# **North Liberty Planning Commission**

Junge Automotive Site Plan

## **Memo**

To: North Liberty Planning Commission  
From: Dean Wheatley, Planning Director  
Subject: Site Plan Approval Request  
(Lot 1 Liberty's Gate Pt 8 & Lot 28 Liberty's Gate Pt 3)

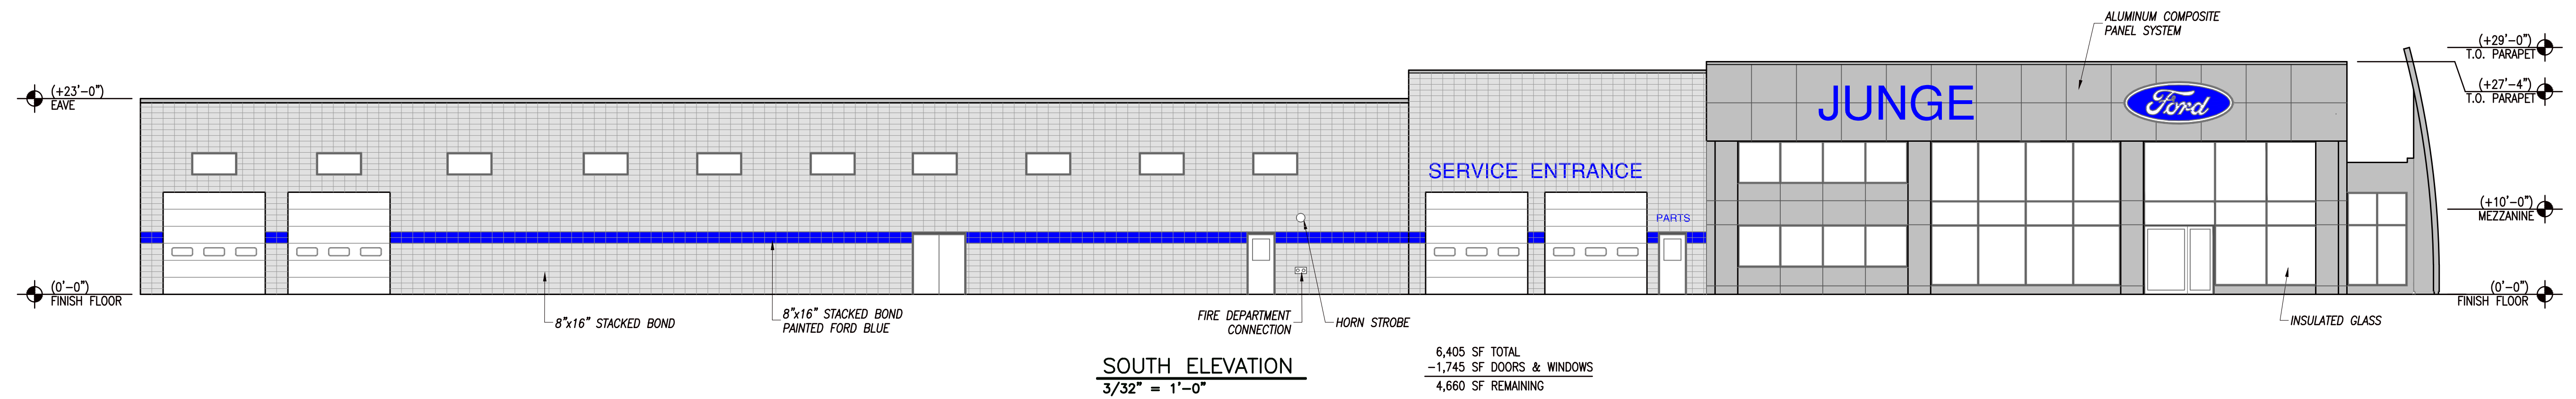
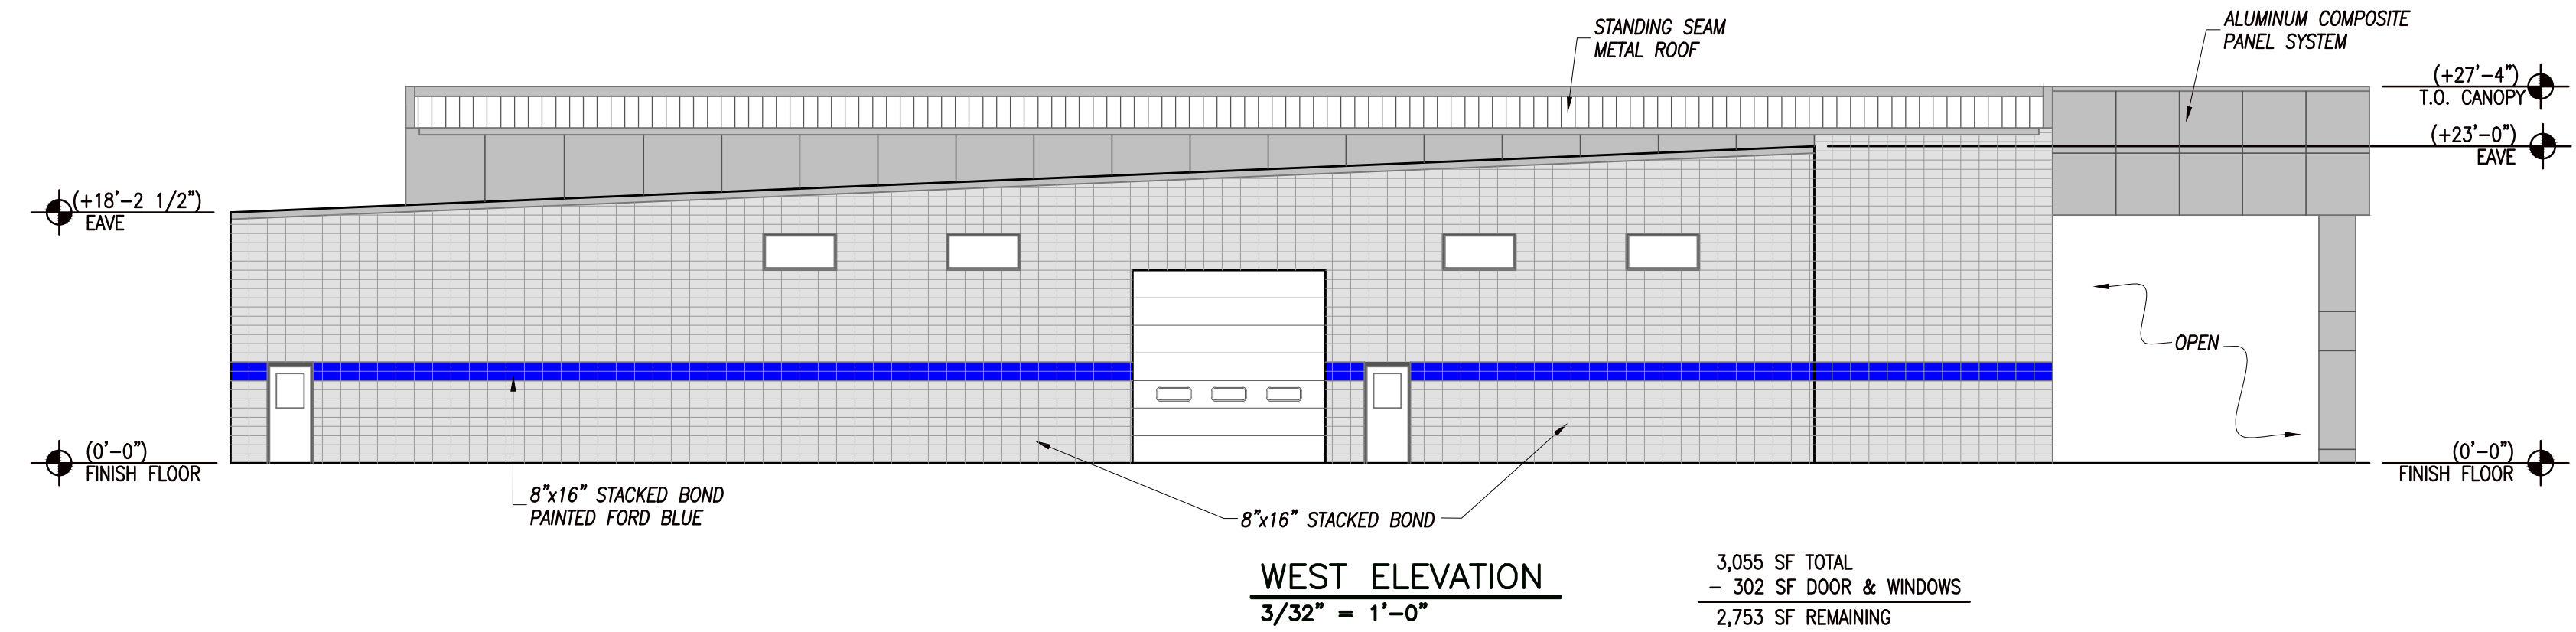
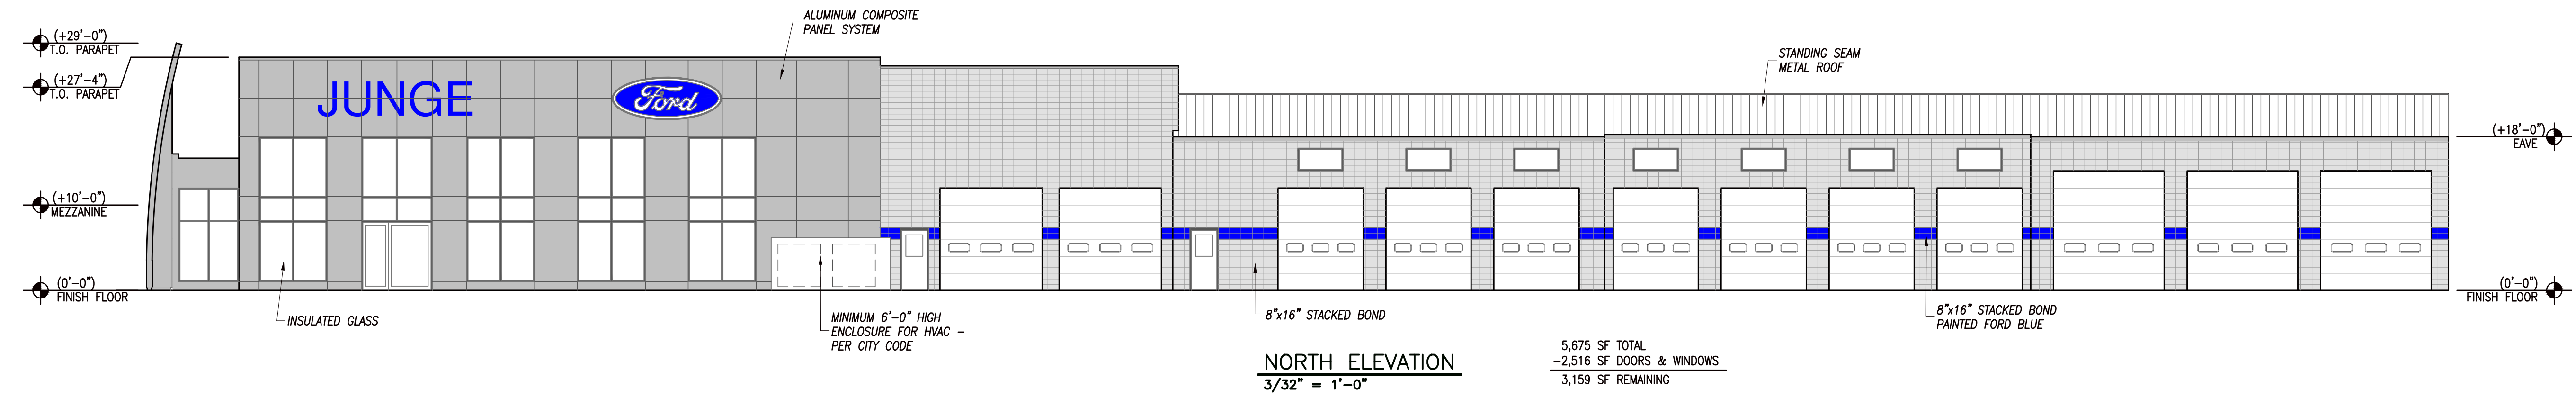
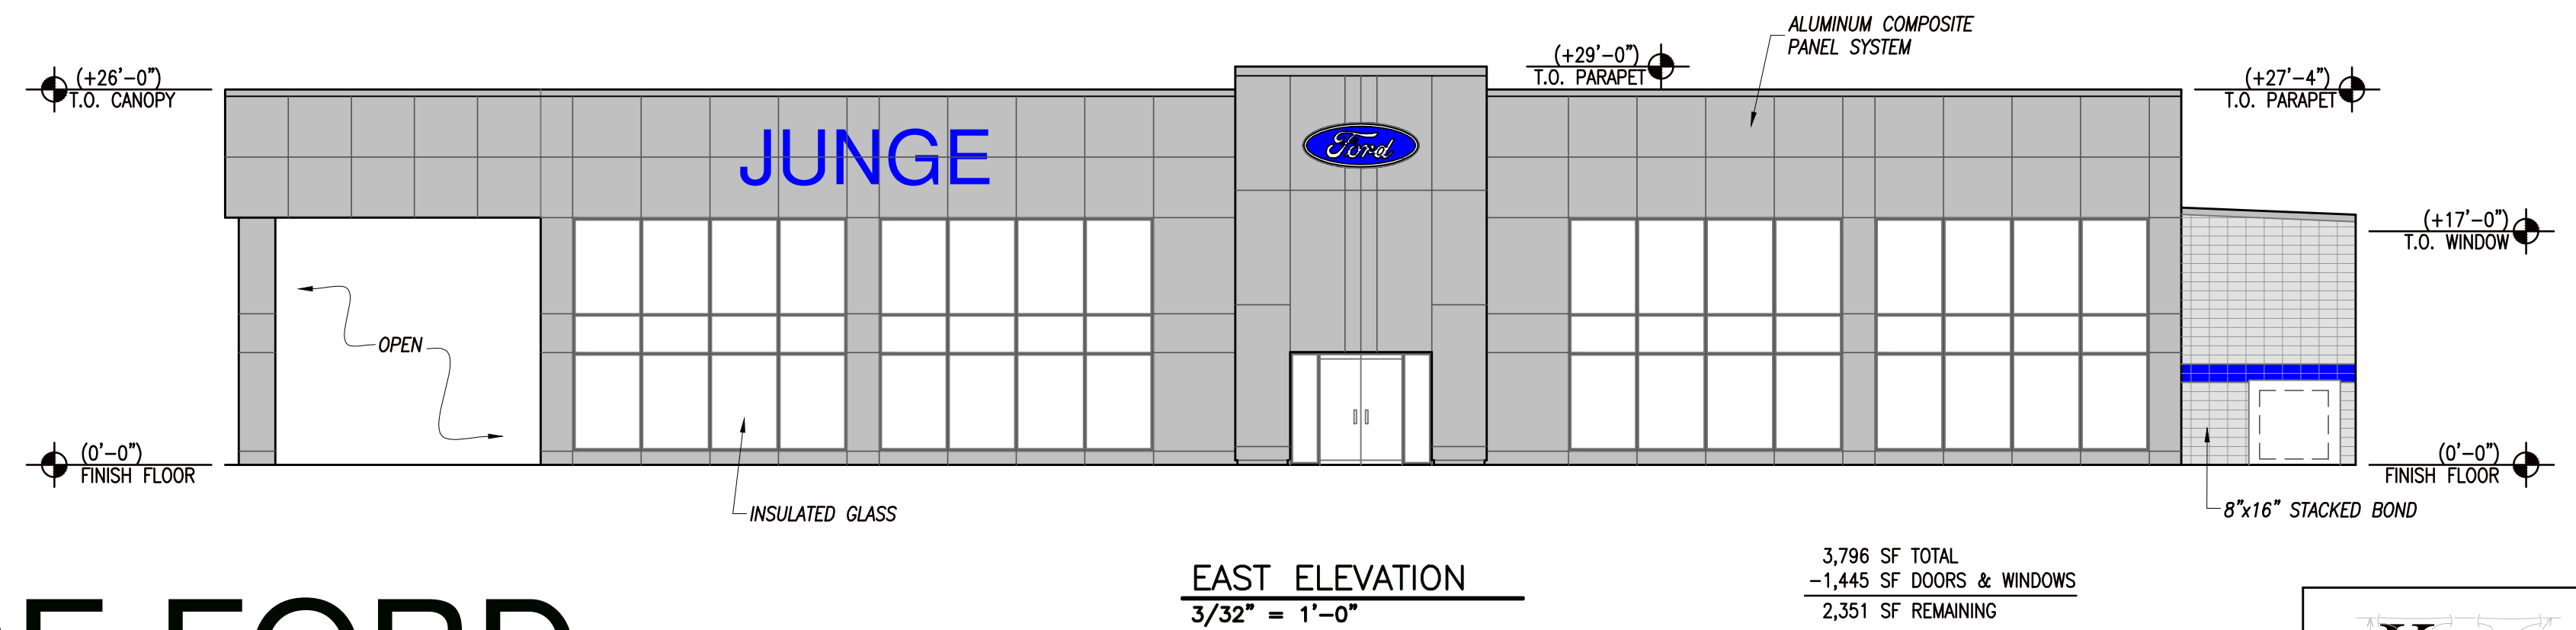
While the building and lot design have progressed significantly from the original submission and technically meets specific design standard requirements, the building itself still is not consistent with North Liberty expectations as cited in this code section:

*Buildings and building features shall be sized and detailed appropriately for pedestrian use. Projected or recessed doorways and windows, awnings, and other architectural features may be used to achieve this design.*

We have allowed designers to use the calculated total amount of masonry where they see fit for best design, and this design uses that flexibility to show a Ford metal siding product on most of the sales portions of the building while using block construction on the rest; however, the overall design of the block part of the building is lacking in human scale and detail because of the large expanses of tall flat walls, many drive-in doors, windows located high on the walls, a large single-slope shed roof

design, no roof overhangs, and very little landscaping. In addition, the Commission and Council should be aware that the plan is to paint the block walls, which minimizes the masonry impact visually, and the block is not specified to be split-faced (so it may be smooth and lacking even more feature interest). Suggestions were made by staff to warm the design and bring the scale of the service area building down, such as adding metal canopies, stacking the windows to bring some down to human level, adding columns or other offsets in the walls, and others.

Negotiations with the owner and with his engineering and architectural design team have been cordial and positive, but it seems that we have progressed in those discussion as far as they can go at the staff level, and staff strongly recommends that the Commission and Council insist on a more human scale design approach for the service area portion of the building. In addition, staff recommends some additional or expanded landscaping in the vicinity of the building, and moving the edge of the pavement along Madison back a few feet so that the berms and plant materials there are not directly on top of the private utilities.

The recommendation from staff is to deny approval of the site plan, and to direct the owner to address issues raised in this report, as provided for in the following code section:
